# Malcolm Hunt Associates

Date: 27 November 2017

Re; *EPL Wharf 6/7 Resource Consent - Response to GDC's s.92 Noise Questions*

**Figure 1** Numbered locations of sound sources used in modelling of increased log handling at Eastland Port.

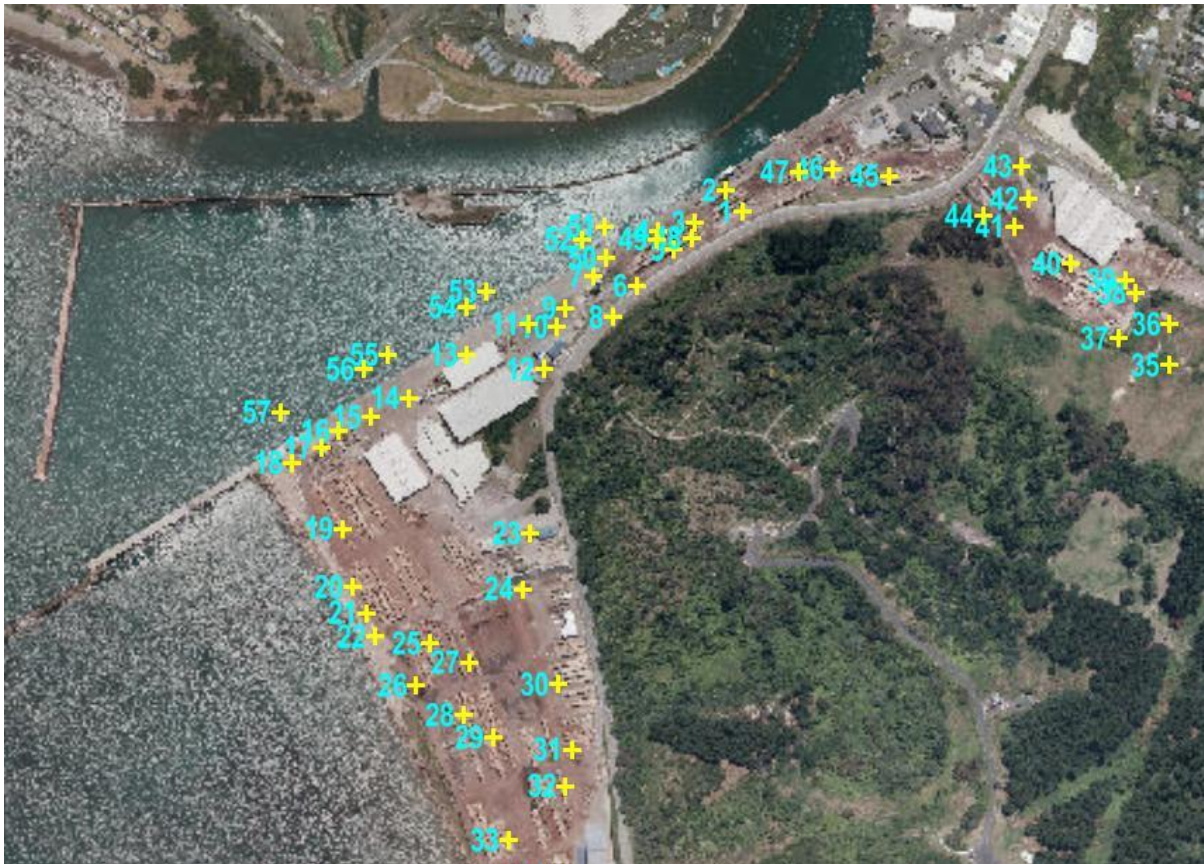
Section 8.5 of the Noise AEE sets out information and analysis to assess whether the proposed works would have the result of increasing the port handling capacity and if so, whether operational port noise emission levels would comply with noise Standards set out in Part C of the Tairāwhiti Resource Management Plan (TRMP)<sup>1</sup>. The assessment is based on the expected limited additional use of Wharf 7 for log handling. To clarify, the assumed growth in log vessels using the port has been taken into account by predicting additional noise associated with approximately 25%, or 80 extra log ships/year that would use Wharf 7, above the ships currently utilising the wharf<sup>2</sup>. The Noise AEE report erroneously refers to current port traffic at 230 log vessels/year. In fact this figure represents the port company's expected growth above the current level of 150 vessels per year. Further detail is provided below on how additional noise from increased utilisation of Wharf 7 has been modelled.

The requested information regarding sound power levels and their locations are set out below. The sound power levels are listed in the attached table with the locations of these noise sources shown in the Figure 1. The sound power levels are based on field measurements of actual equipment operating in and around the port during 'essential port activity' adjusted to take account of increased port activity.

Sound level predictions were conducted using a computer-based prediction program developed by Malcolm Hunt Associates which has as its base the algorithms set out within ISO 9613-2 *Acoustics — Attenuation of sound during propagation outdoors — Part 2: General method of calculation*. This method for calculating the attenuation of sound during propagation outdoors predicts levels of environmental noise at a distance from a variety of sources in terms of the equivalent continuous A-weighted sound pressure level (LAeq). The following information describes the main attributes of the prediction method;

- a) The prediction method utilises various input variables including octave band sound power levels at source, air absorption values based on temperature and humidity. Sound power data used within the model are the sound power levels presented in Table 1 (attached).

- b) The predictions were designed to conform with the recommendations of NZS6801:2008 *Acoustics – Measurement of Environmental Sound* which states, at clause 7.1.2, that slightly enhanced sound propagation conditions should be adopted for predictions of environmental sound. The ISO9613-Part 2 method predicts sound levels under meteorological conditions favourable to propagation of sound (such as light downwind conditions or under mild temperature inversions).

- c) Sound attenuation due to acoustic screening has been taken into account by use of a digital terrain model sourced from Council's LIDAR data for the area. Where screening occurs (i.e. there is no line of sight between the source and the receiving position) acoustic screening values are included in the calculation based on noise screening principles of Maekawa<sup>3</sup>.
- d) No acoustic screening effects have been included caused by vessels at berth which do form an effective shielding for log handling activities taking place close to the vessel for noise received at sites located to the south of the port, across the Turanganui River. This is likely to have caused an over-estimate of received noise received in this area.

**Figure 2** Detailed minute x minute measured LAeq and LAFMax sound levels for the morning of 24 August, as per Section 5.4 of the Noise AEE.

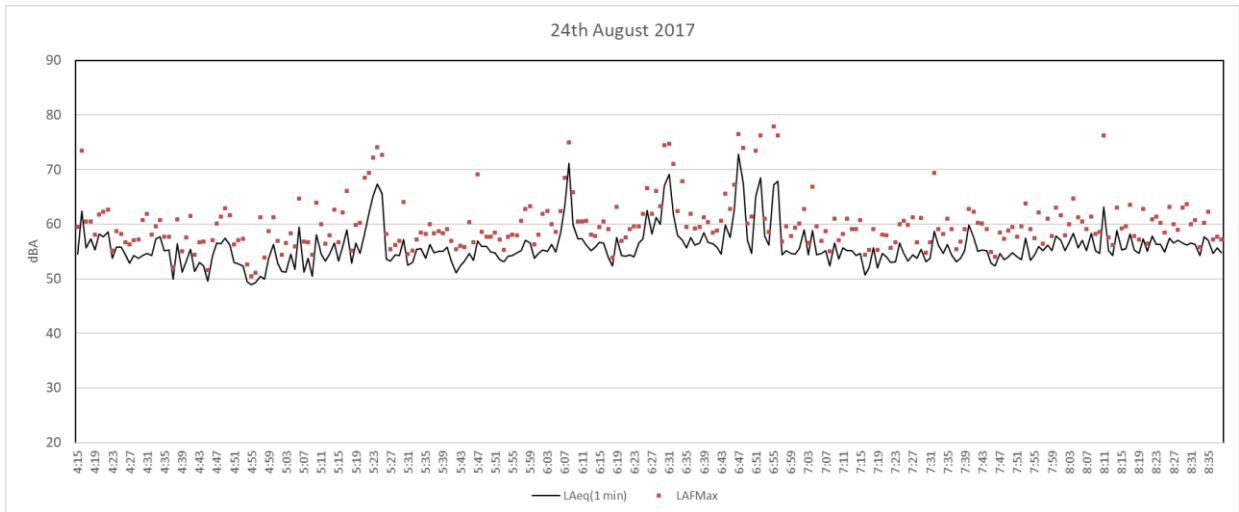
***Comment on the peaks shown in the graph of measured sound levels in Section 5.4 towards the end of the measurement period and the potential for the 60 dB short-term noise limit to be exceeded?***

The measured LAeq(15 min) sound levels for the relevant time period are:

We are unable to comment on the reasons for the exceedances over 60 dB via direct observations at the time as the measurements were unattended at that time (measurements were taken by an automated logger). We have been able to reproduce the data for the relevant time period in minute x minute format in Figure 2 in the interests of providing more detail.

Figure 2 shows the elevated noise levels are present over short time periods of 1 to 2 minutes which occur intermittently between 5.30am and 7am.

We have enquired with the hotel management who have not been able to shed any light on this. As can be seen by the sound levels shown in Section 5.4 of the report, we consider the elevated sound levels are out of place compared to longitudinal noise profile exhibited by the essential or non-essential port activities taking place over the three preceding days (during which more or less continuous log loading activities took place).

We consider the most likely cause was localised sound due to non-port related source. Most likely these extraneous sounds are due to vehicle movements within the hotel car park, close to the monitoring location. A public walkway also passes near the location where the logger was positioned. Ideally these events should have been excluded from the graph, however the monitoring results shown in Section 5.4 include all port and non-port noise occurring in the area and some 'contamination' by extraneous sources at times is not unexpected.
